Norfolk Vanguard Offshore Wind Farm Development Consent Order (the Project)
Case reference no: EN010079
The Applicant: Norfolk Vanguard Limited

Request to submit information into the Examination: Application Documents Errata, and Change Report.

Norfolk Vanguard Offshore Wind Farm Change Report

Applicant: Norfolk Vanguard Limited
Document Reference: Pre-ExA; Change Report; 9.3

Title:
Salle route amendment

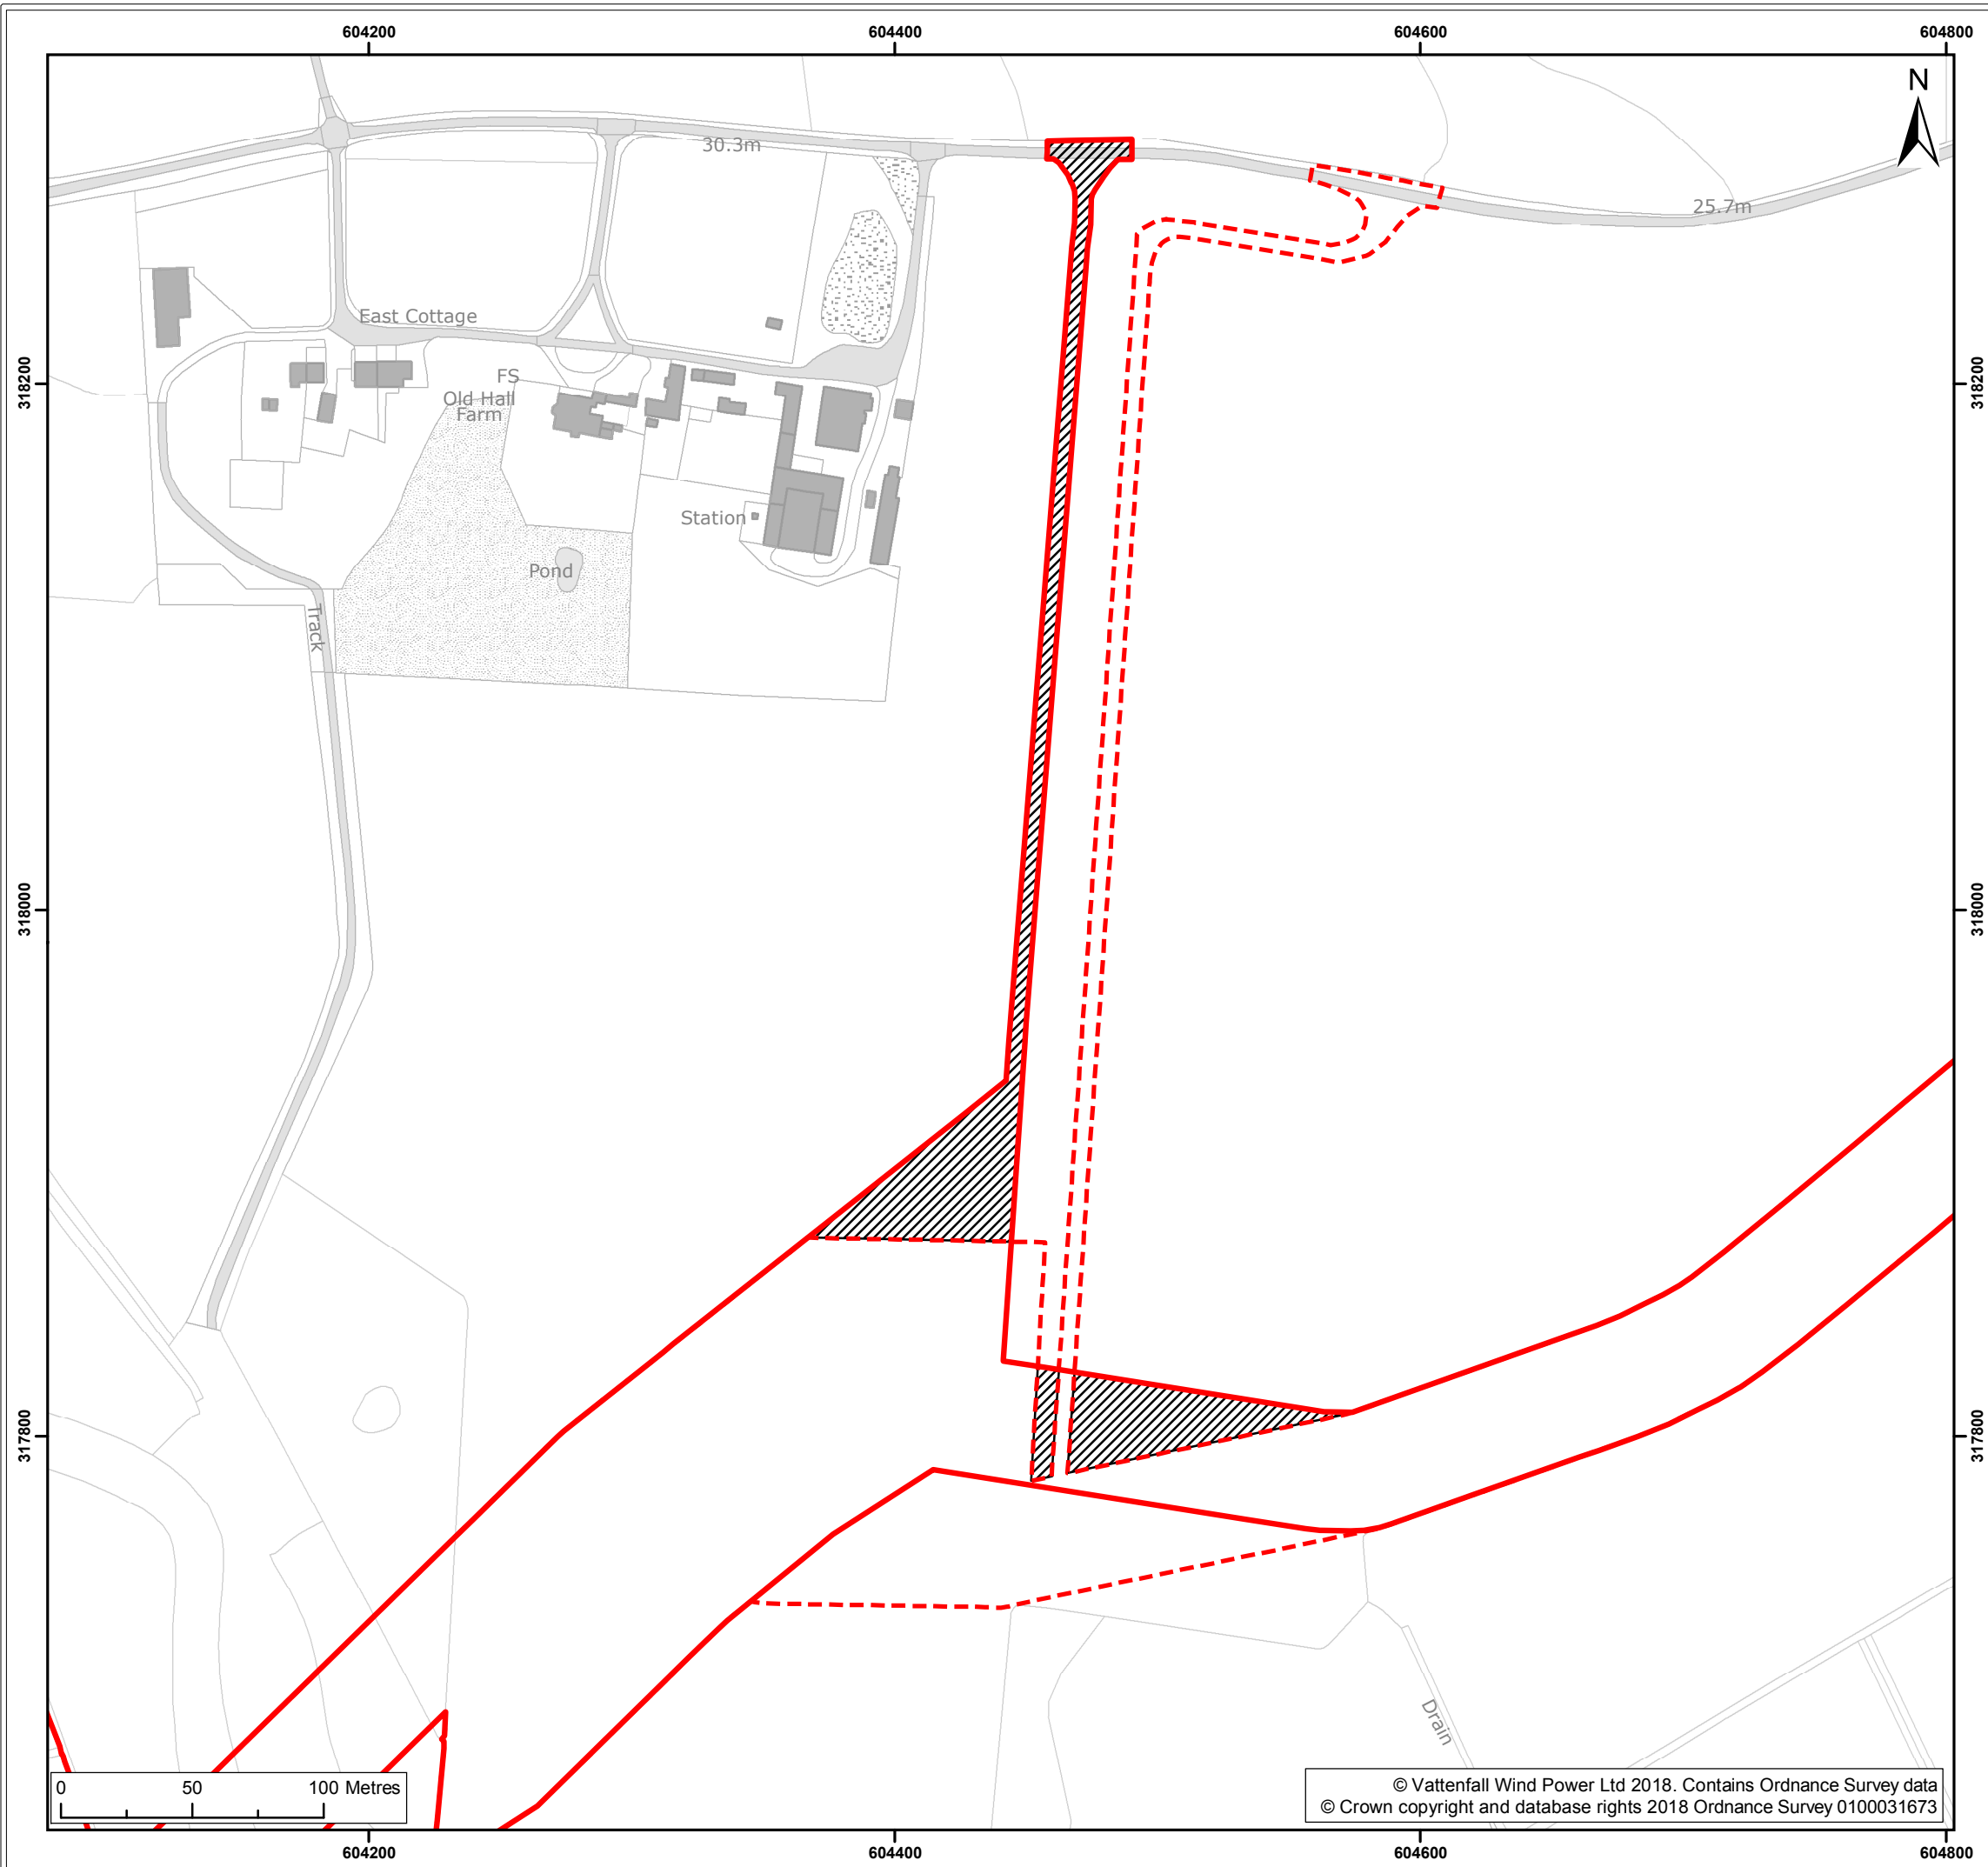
2.2.1 Cable Route amendment - Salle Estate (Plot No. 22/01, 22/03 and 22/04 – Land Plans Sheet 22)

60. A minor amendment to the onshore cable route has been requested in this location by the landowner. The location is north of Reepham centred on National Grid Reference TG 105 239. The cable route amendment has been requested by the landowner to minimise interaction with a parcel of land put forward in a “call for sites” for potential future housing allocations, as part of the Greater Norwich Local Plan.

61. The proposed route amendment is shown on Figure 1, which also indicates the extent of the Order limits within the original application that are no longer required. The route amendment is a total length of 460m and would replace a length of the previously submitted cable route that had a total length of 410m. The route amendment is wholly located within the same arable field as the original alignment and located wholly within the EIA study areas identified within the submitted ES.

Figure: 4	Drawing No: PB4476-008-002-004				
Revision: 03	Date: 28/11/2018	Drawn: LB	Checked: JA	Size: A3	Scale: 1:5,000
Revision: 02	Date: 08/10/2018	Drawn: LB	Checked: JA	Size: A3	Scale: 1:5,000

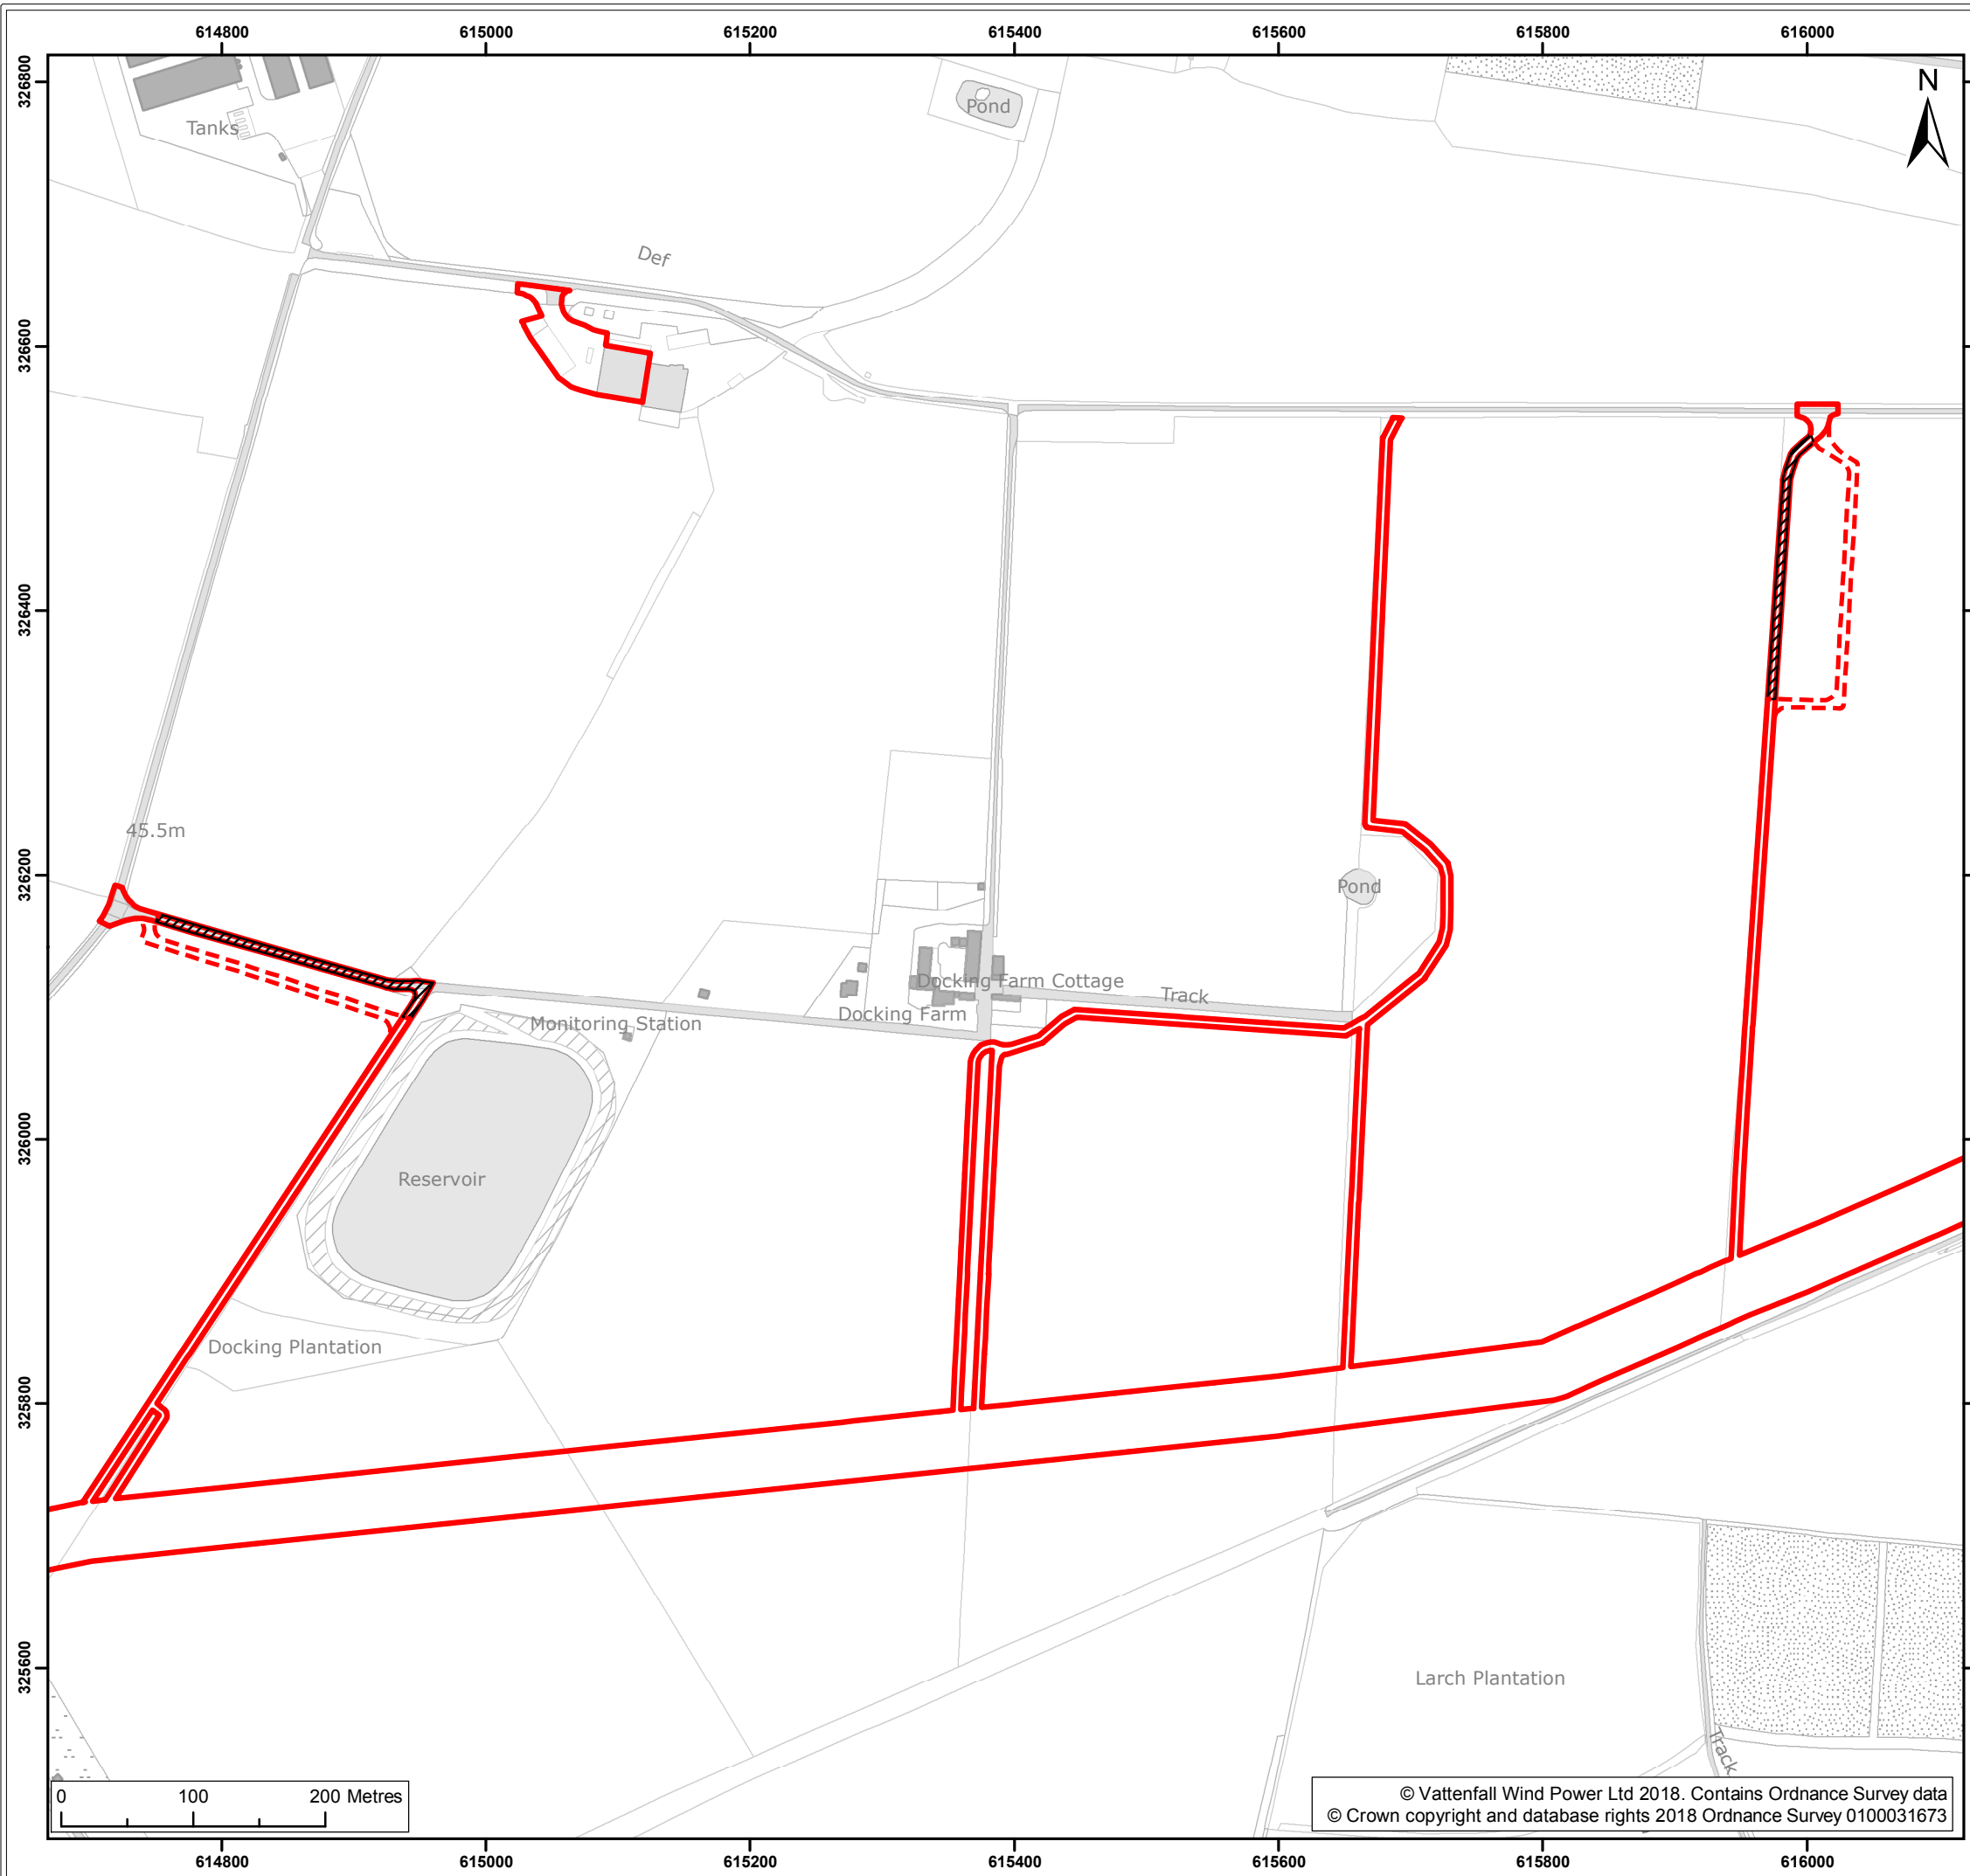
2.2.4 Access amendments – EF Harrold (Plot No. 18/06, 18/07, 19/02 and 19/03 – Land Plans Sheets 18 and 19)

77. The proposed changes to these two construction accesses are shown on Figure 4, which also indicates the extent of the Order limits within the original application that are no longer required.

EF Harrold Amendment to eastern access: Relocation of a 200m length of the north-south construction access to 50m east (centred on National Grid Reference TG 160 264). Figure 4.	Requested by landowner to avoid a block of vegetation used for shooting cover.	No changes	Land Plans, Works Plans and Book of Reference to be updated. No other documents affected.
S Hammond 220m north-south section of the proposed access to be removed and use the existing property for this stretch instead, with a 15m access introduced to connect the property access to the project	Requested by landowner to reduce the length of new access to be constructed at this location.	No changes.	Land Plans, Works Plans and Book of Reference to be updated. No other documents affected.
